**PRELIMINARY DECISION**  
**CitiPower distribution**  
**determination 2016–20**

**Attachment 5 – Regulatory**  
**depreciation**

October 2015

**Figure 5.1 Projection of the value of assets for 'Distribution system assets' asset class over time (\$million, 2015)**

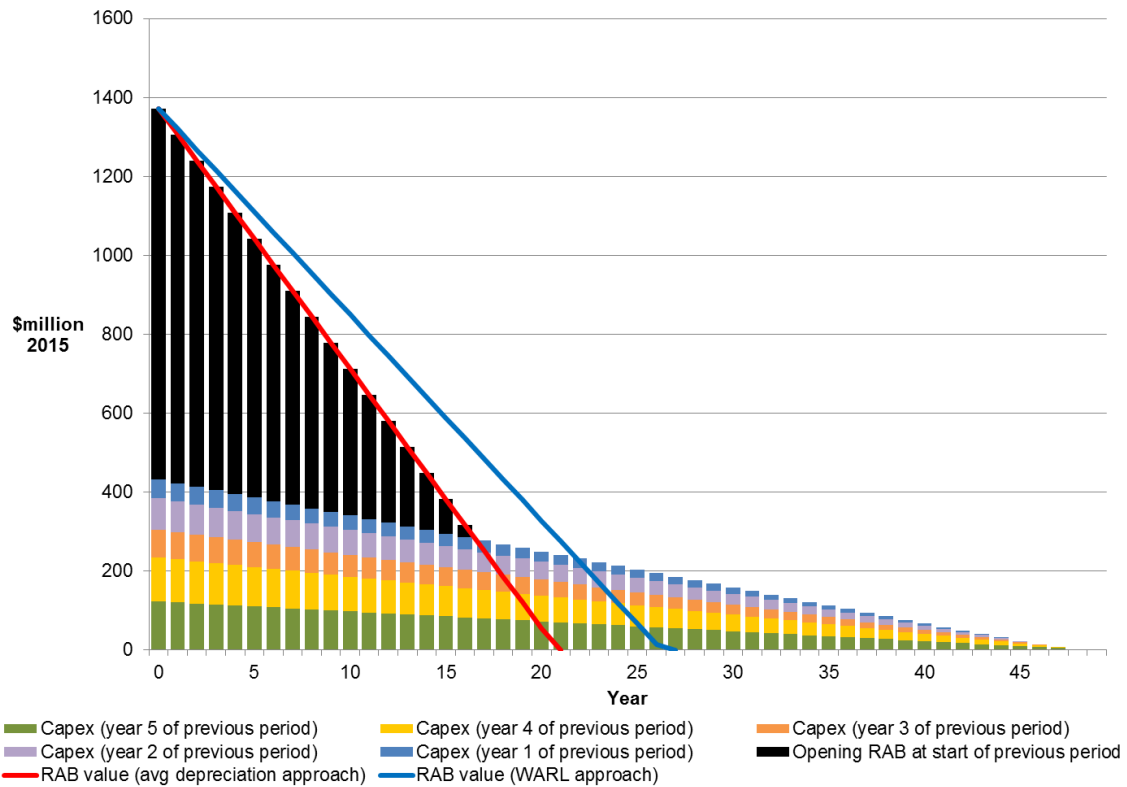
Figure 5.1 shows the impact of the year-by-year tracking (stacked columns, with each bar representing a different year of capex that will expire at a different time), WARL (blue line), and average depreciation (red line) approaches in relation to CitiPower's 'Distribution system assets' asset class. This example assumes the asset class incurs no further capex.

The adoption of year-by-year tracking will mean that the value of distribution system assets in the RAB as at 1 January 2016 will not be fully depreciated until 49 years into the future. Under CitiPower’s proposed average depreciation approach these would have been fully depreciated in 21 years, while under the AER’s preferred WARL approach the assets would have been fully depreciated in 27 years. As illustrated in the figure above, the WARL approach leads to under-recovery and over-recovery of depreciation being balanced out through time—over the lives of all assets in the group.<sup>54</sup> The average depreciation approach does not achieve this balancing, as there is no recognition of when older assets expire.<sup>55</sup> However, with the NER requirements limiting assessment of depreciation to the nature of the assets and their expected economic lives, we accept year-by-year tracking as being superior in this regard.

As is shown in Figure 5.1, all three approaches result in total depreciation equalling (in real terms) the initial value of the assets, and so all three approaches conform with clause 6.5.5(b)(2) of the NER.<sup>56</sup> However, the three approaches differ with regard to the fulfilment of clause 6.5.5(b)(1) of the NER:
